## Referral 45: Amess Road Precinct Structure Plan

### Priority Projects Standing Advisory Committee Report

**11 April 2025**

**Figure 14** Sandy Creek Stormwater drainage projects (with property ID)

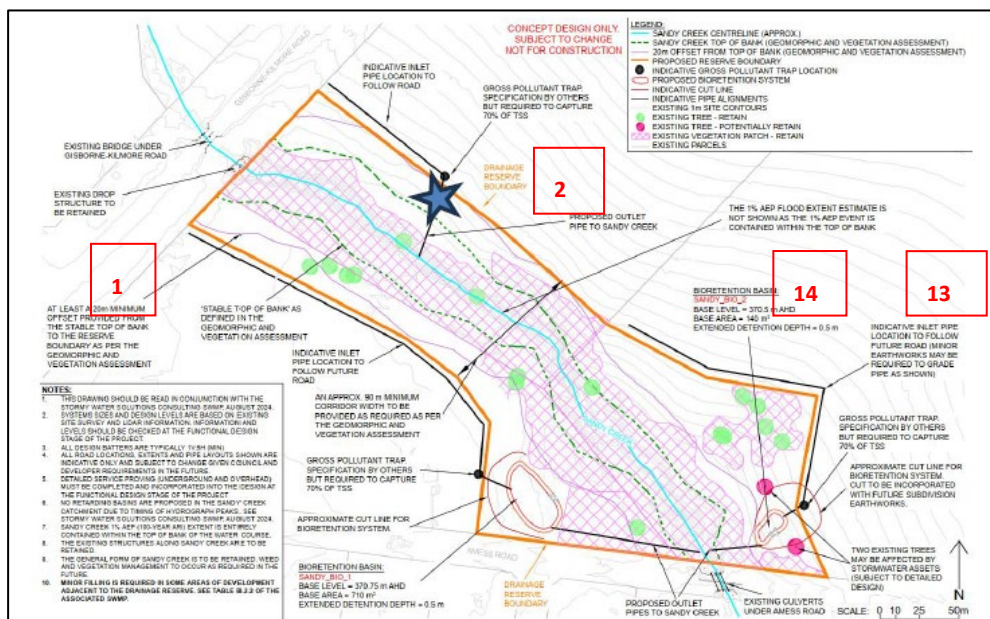
The issue is whether each of the three properties abutting Sandy Creek should treat their stormwater runoff with their own bioretention basin.

Figure 15 identifies the two basins proposed by the SWMP and marks the third basin recommended by Mr Swan.

- 5. **Amend the Amess Road Precinct Structure Plan in accordance with the Proponent’s Final Day version<sup>3</sup> and:**
  - a) **amend Plan 12 at SW-01 to show three Stormwater Quality Assets (bioretention basins) in the Sandy Creek catchment**

**Figure 18** PSP Street network

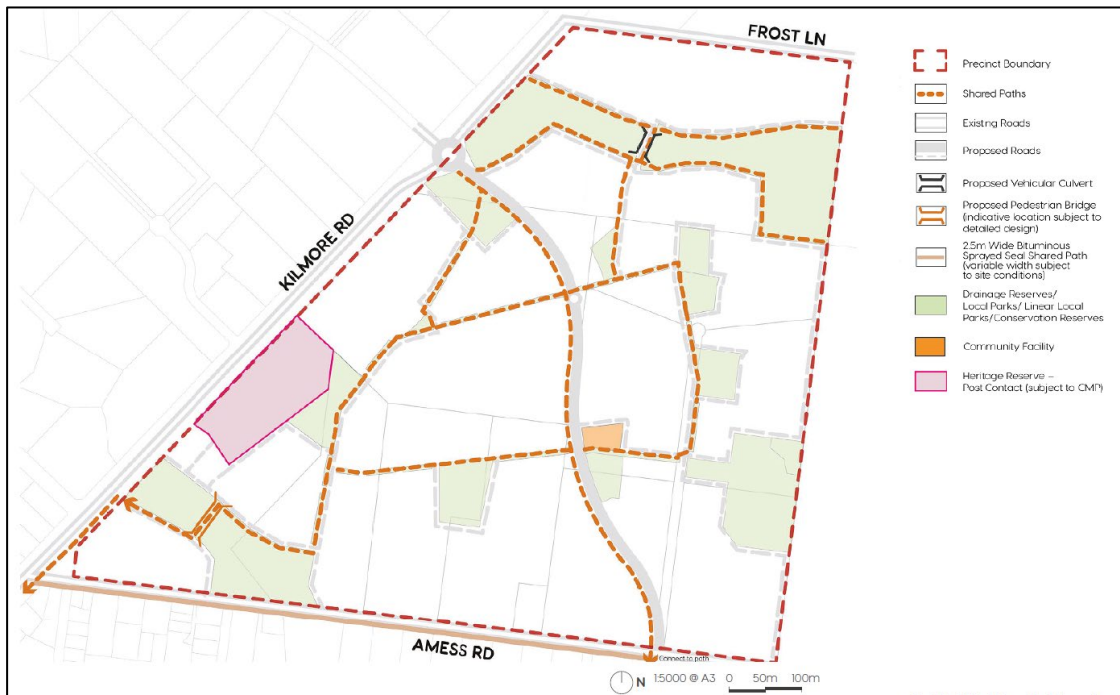
Figures 19, 20 and 21 show the street network, off-road shared path network and DCP funded transport projects (Final Day versions). The DCP items include:

**Figure 19** PSP Off road shared path network

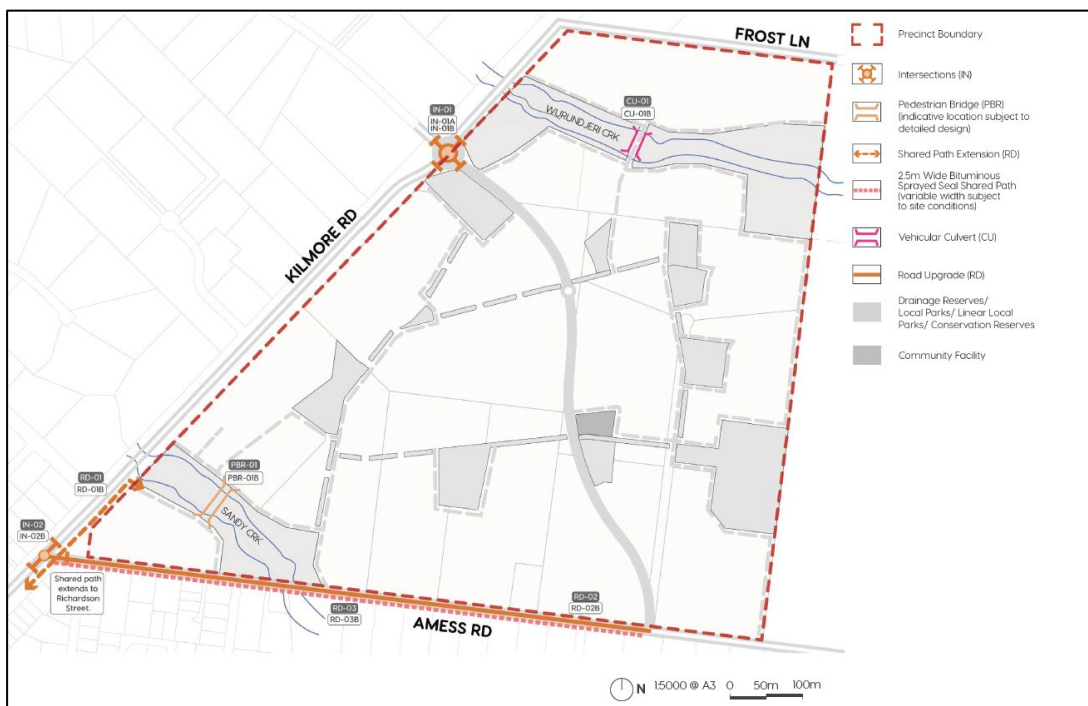
**Amend Plan 10 of the PSP to notate the Amess Road shared user path as '2.5m wide tinted concrete shared user path (variable width subject to site conditions)'.**

- b) **amend Plan 10 to notate the Amess Road shared user path as ‘2.5m wide tinted concrete shared user path (variable width subject to site conditions)’**

**Figure 22** Kilmore Road and Amess Road intersection (IN-02B)

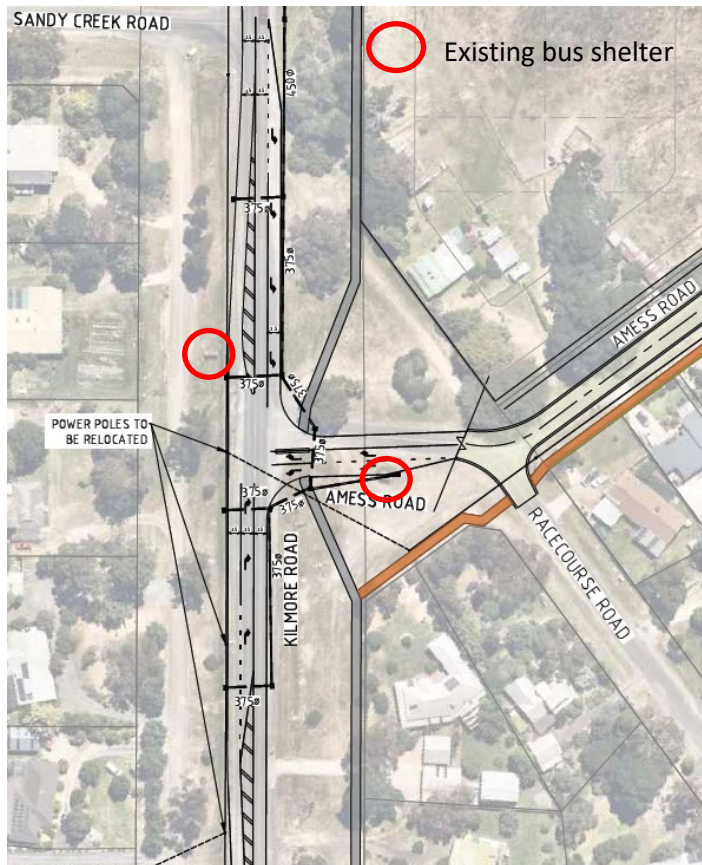
- undertake a Road Safety Audit of IN-01B to determine an appropriate pedestrian crossing design and address other potential safety issues**
- revise the concept design and costings for IN-01B based on the findings of the Road Safety Audit**
- include the revised concept design and costings for IN-01B in the DCP.**

- a) **undertake a Road Safety Audit of IN-01B and IN-02B to determine appropriate pedestrian crossing designs and address other safety issues**
  - b) **revise the concept design and costings for IN-01B and IN-02 based on the findings of the Road Safety Audit**
